# Abnormal Whistle Noise From Vehicle Front

YEAR(S)	MODEL(S)	ADDITIONAL INFORMATION
2020 - 2022	Highlander, Highlander HV

**Figure 1. Radiator Grille Bracket Before 11/5/2021**

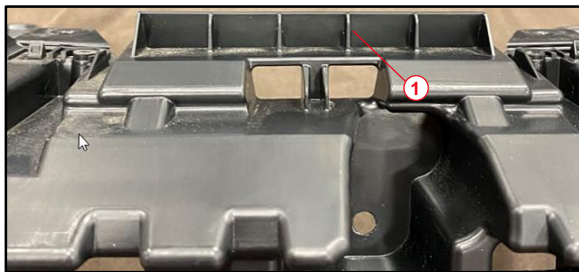
Some 2020 – 2022 model year Highlander (except XSE models) and Highlander Hybrid vehicles may exhibit an abnormal whistle noise from the front when driving over 35 mph. This may be caused by the radiator grille bracket. A new radiator grille bracket has been developed to address this condition. Follow the Repair Procedure in this bulletin to address this condition.

- Ensure the NEW radiator grille bracket received is the correct part.  
The OLD and the NEW parts differ in the shape of the ribs directly above the emblem cut out. The OLD grille bracket has closed ribs in the center, while the NEW part has open ribs in the center. Refer to Figure 1 and Figure 2 below for reference.

<b>1</b>	<b>Ribs With Closed Shape</b>
----------	-------------------------------

<b>1</b>	<b>Ribs With Open Shape</b>
----------	-----------------------------

- Remove and replace the radiator grille bracket.

**Be careful NOT to break ANY clips/tabs when transferring the hood to radiator grille seal from the OLD radiator grille bracket to the NEW radiator grille bracket.**
